DESIGN REVIEW & PRESERVATION BOARD

LOCATION: 300 Capitol Mall

PROPOSAL: To construct a 19-story office and bank structure and 7 story parking structure recessed within office structure (1 additional level of parking will be below ground)

DR 82-186

ROOF AND HELISTOP PLAN

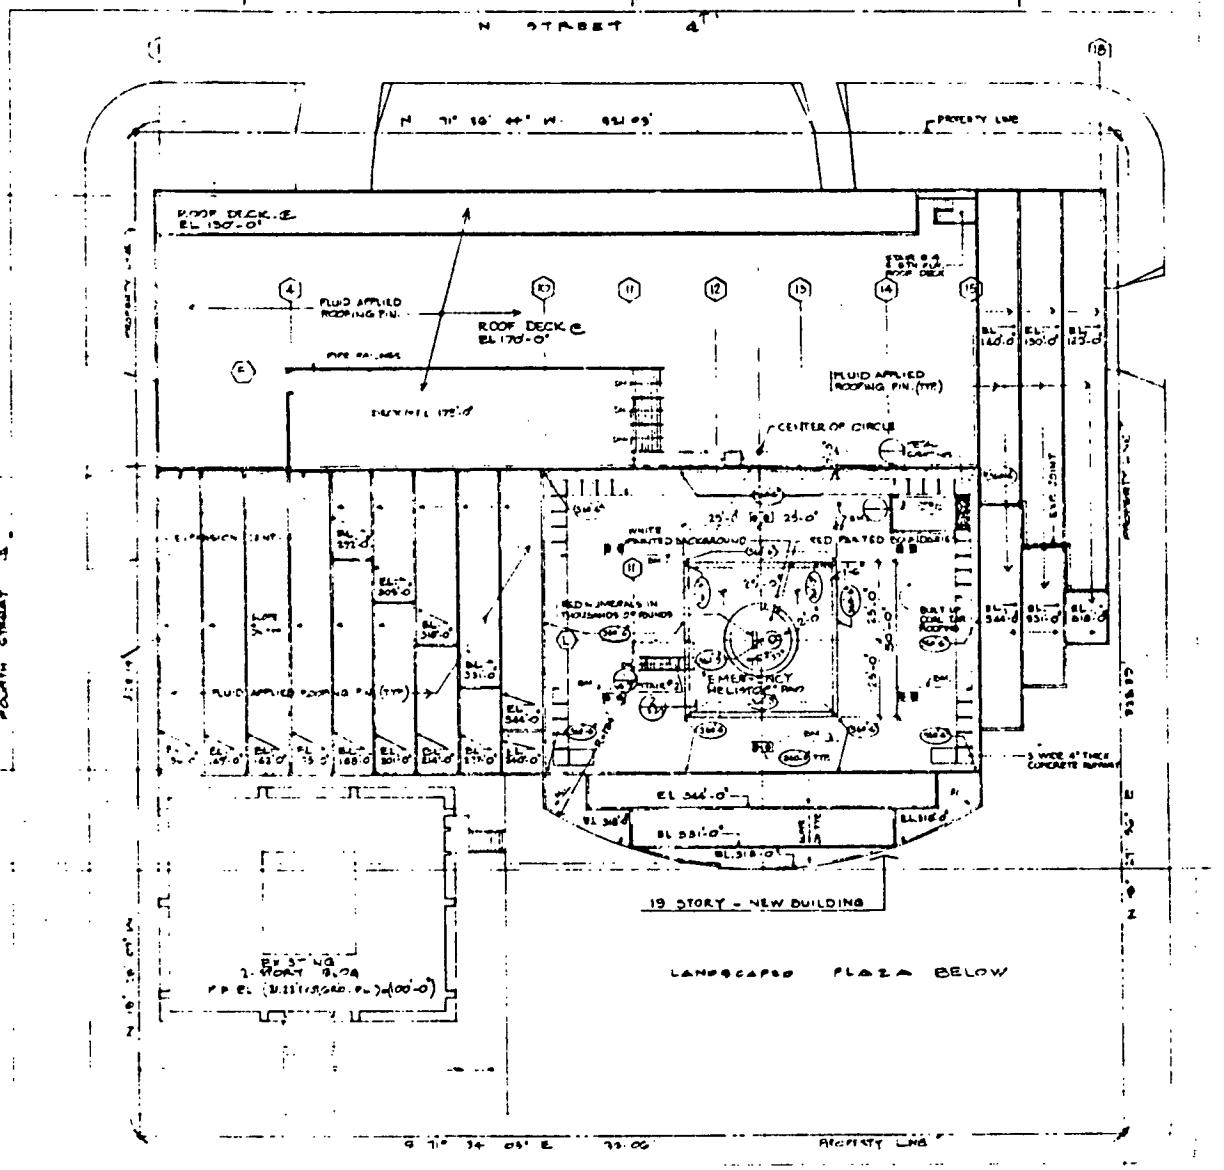
4. The heliport pad on the roof top of the structure shall be redesignated as a helipad. The pad shall be limited to emergency use (e.g., fire rescue) only.

SOUTH ELEVATION

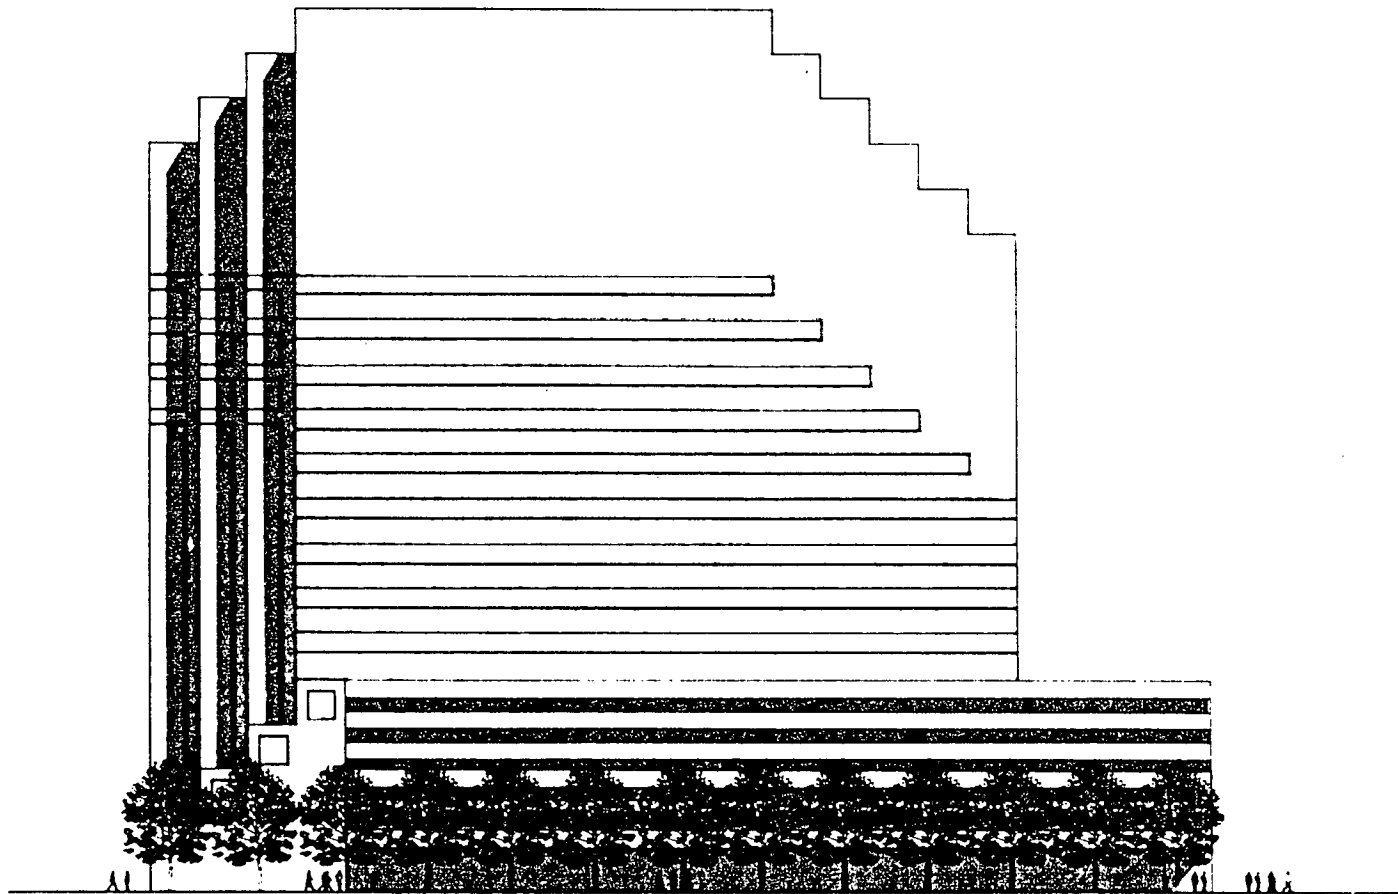
- C. The rear or south elevation is much the same even with the parking structure one level higher. The office tower is made visually stronger by the use of more refined detailing on the concrete panels and the horizontal band of louvers at the 19th floor. At ground level, the proposed louvers work well. They wrap around the south west base of the parking structure and are held visually in place by the strong vertical ending column at the south east corner. Planting of the roof deck over the parking structure will add an interesting textural element.
- D. The west side elevation has the same feeling of mass but is now more refined. The louvers at the 19th floor will not be a strong visual element and those at the parking structure ground level continue the design element found on the south elevation.

EAST ELEVATION

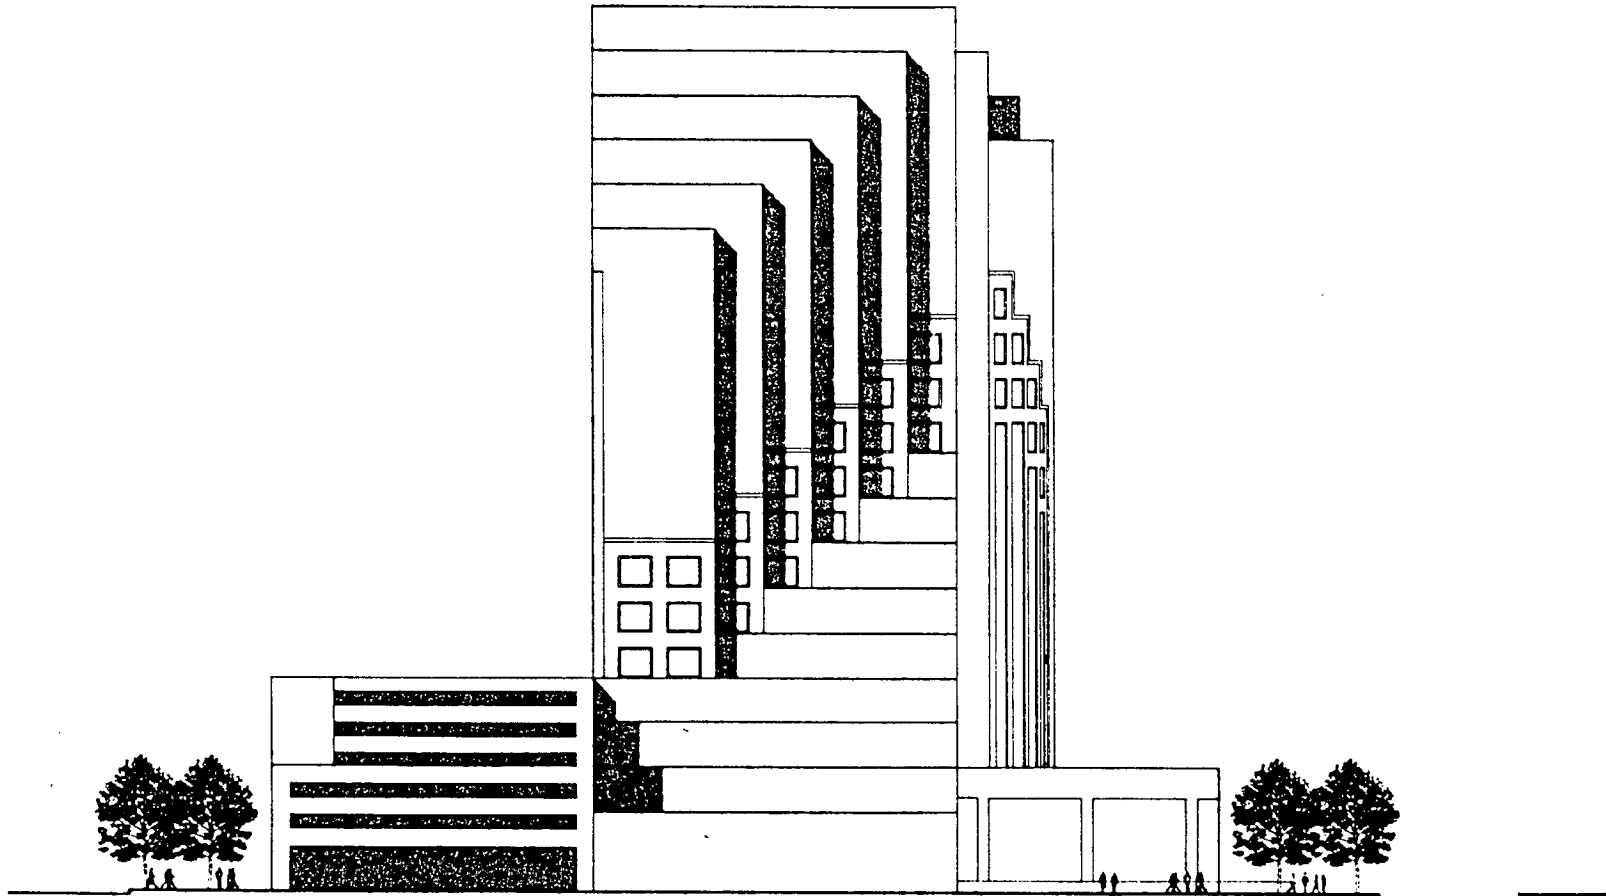
- B. The east side elevation has changed significantly. The stair step massing remains but the precast spandrel detailing is now stronger. The parking structure has increased by one level and what was to have been a much longer glass and spandrel side elevation of the bank has now been shortened through the addition of louvers. These same louvers spread upward to the 5th floor of the Office Tower as well as being located on the first 21 feet of the parking structure. The louvers again appear on all elevations at the 19th floor mechanical equipment level. Roll-up grille doors are now placed at ground level for access to the loading and unloading area.

STAFF EVALUATION: Staff feels that the project is well designed but has one problem area. That is the east side elevation. The shortening of the glass and concrete bank facade and the extensive use of louvers detracts from the total design concept of the building. Even though the third, fourth and fifth floor setbacks break up the massing of the louvers, staff would prefer to see the ventilation needs handled in some other manner. The shortening of the bank's concrete and glass facade is not at all what the Board had in mind when approval of the remodel was granted in October, 1982.

- materials sample submitted*
1. Architect to rethink the use of, or handling of, the louvers on the east elevation of the bank/office tower. Revised drawings to be presented to the Board for review and approval.
 2. Items 1, 3, 4 and 5 under "Site Development Plan" to be returned to the Board and other appropriate City departments for review and approval.
 3. The architect to comply with the concerns as noted in the attached memorandum, to Bill Edgar, Director, Sacramento Housing and Redevelopment Agency, dated October 12, 1982. *showers only problem*

NORTH ELEVATION

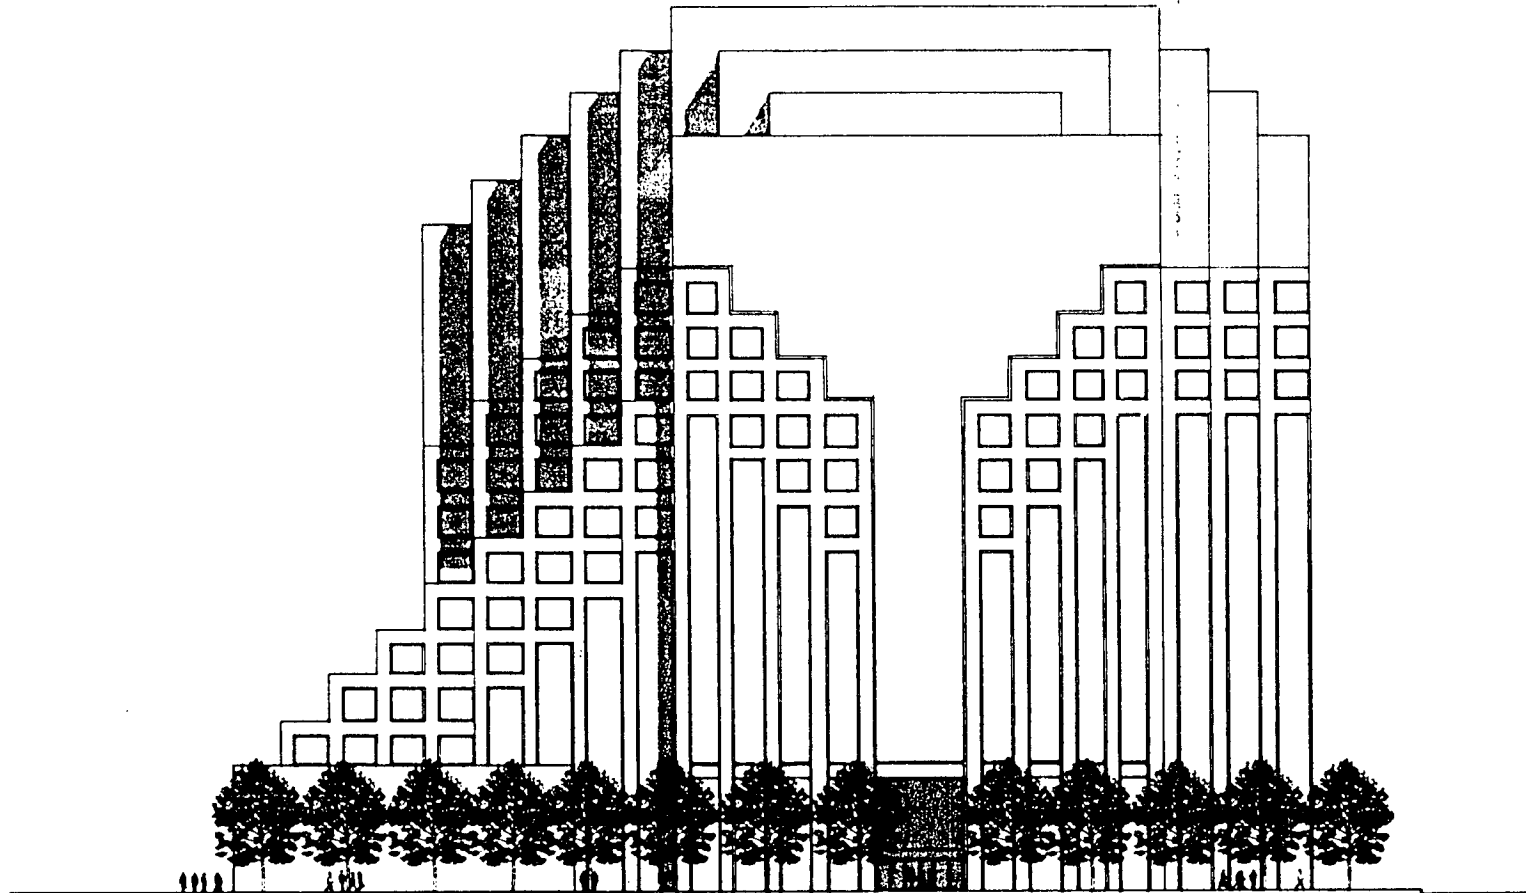
- A. The front or north elevation has remained much the same. The height of the entry has grown and the new facade design of the bank building has only a minor change from that reviewed by the Board in October 1982. The overall detailing has been sharpened.
